### Development Commission

- a) **Sunset 7 Apartments - Site  
Development Permit - SDP16-00004**

**REQUEST:** Site Development Permit APPROVAL for redevelopment of an existing residential lot into a 7-unit 4-story multi-family apartment (See Attachment 5 for plans and elevations).

**2.2 Nonmotorized facilities (IMC 18.07.080)**

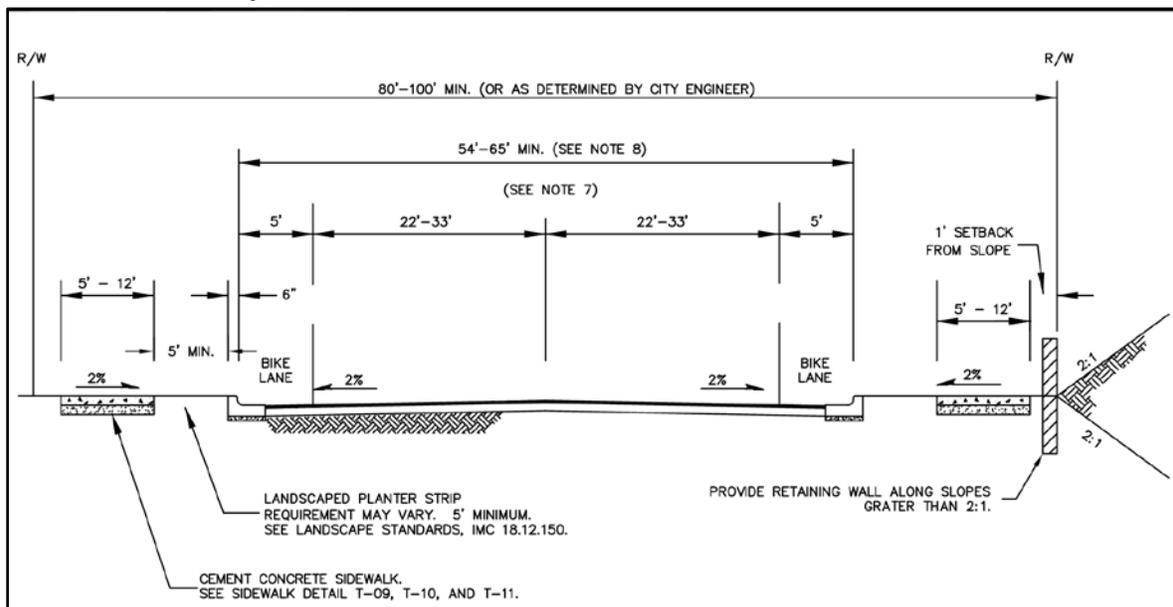
Based on the section drawing above (see Section Detail No. T-13 of the City's Street Standards) a 5 – 12 foot wide raised sidewalk and at least 5-foot wide planter strip is required on each side of the minor arterial.

The Applicant will be required to provide a fee-in-lieu of constructing new sidewalks on Sunset Way (Please see Street Improvement staff discussion at the end of this Staff Report for a detailed explanation of this requirement, and the associated condition of approval.)

Fig. 4. Red arrow shows length of alley to be repaved by Applicant. Yellow square delineates the project site.

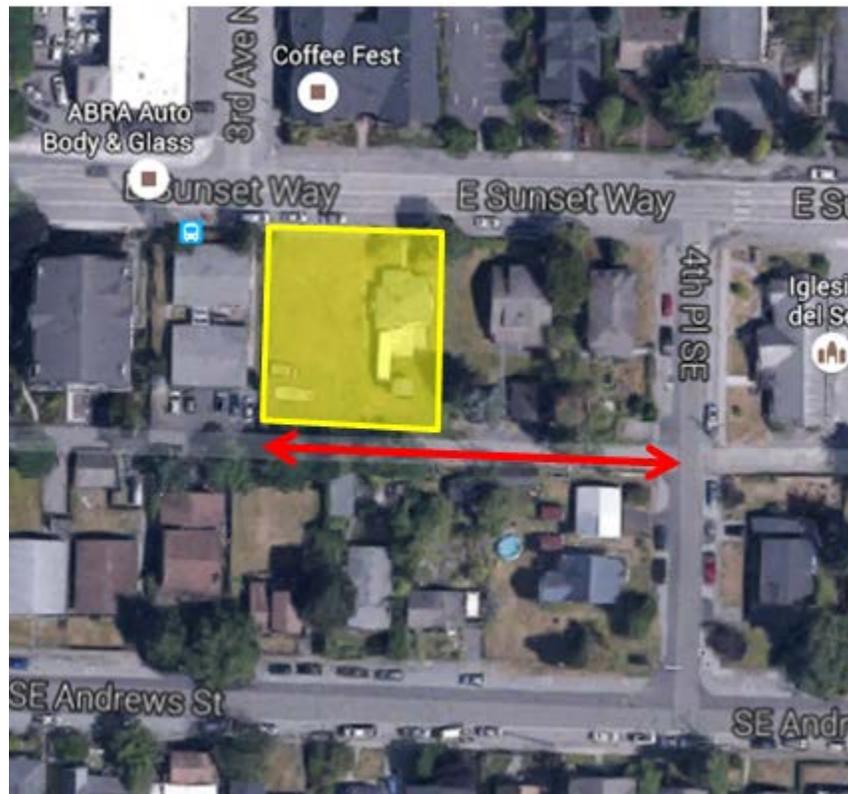
**Condition 2: *The alley shall be repaved to provide unobstructed passage for the full 20-feet width required, from the western property line of the Sunset 7 project to the edge of the right-of-way of 4<sup>th</sup> Place SE.***

- 2 The alley shall be repaved to provide unobstructed passage for the full 20-foot width required, from the western property line of the Sunset 7 project to the edge of the right-of-way of 4th Place SE.

Sheet  
**L1**  
 of 1

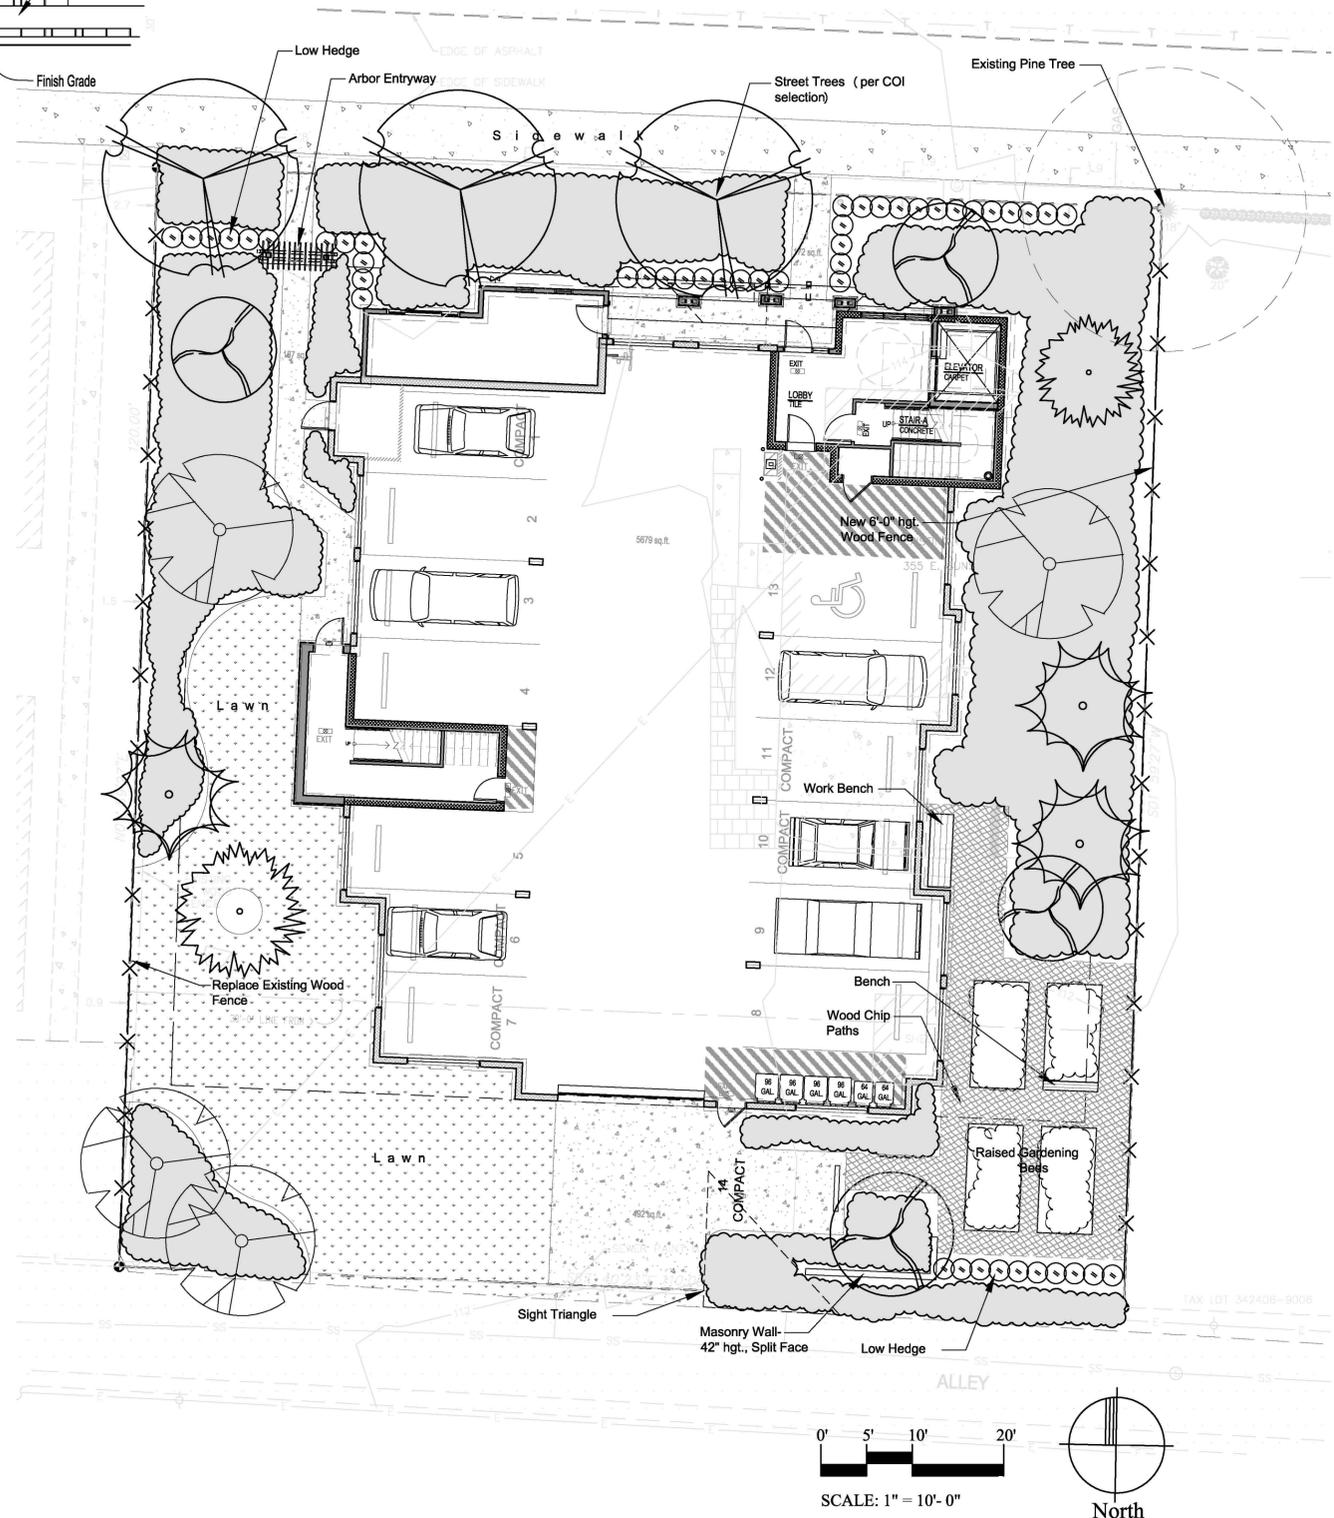
The Landscape Plan shows vegetation along the east and west parking garage walls but none for the southwest corner. Additional landscape screening will be required for this area. The proposed screening for the one parking space in the rear yard is shown as a combination of a 42-inch wall and vegetation, but no details of the height. While the plans show a sight triangle for the driveway, the City Streets Standards do not have sight triangle requirements for alleys and driveways connecting to alleys. Therefore, the screening for this parking space shall be required to meet the standards prescribed in IMC18.12.100.

**Condition 7:** *The Plant Schedule of the Landscape Plan shall include the following information for each plant species, in addition to planting size and spacing:*

- *Size of plant at maturity, including height and width/spread*
- *Plant category, whether deciduous or evergreen/coniferous*
- *Additional plant characteristics required to meet the standards, such as drought resistance and which plants will provide year-round color*

- 7 The Plant Schedule of the Landscape Plan shall include the following information for each plant species, in addition to planting size and spacing:

- Size of plant at maturity, including height and width/spread
    - Plant category, whether deciduous or evergreen/coniferous
    - Additional plant characteristics required to meet the standards, such as drought resistance and which plants will provide year-round color
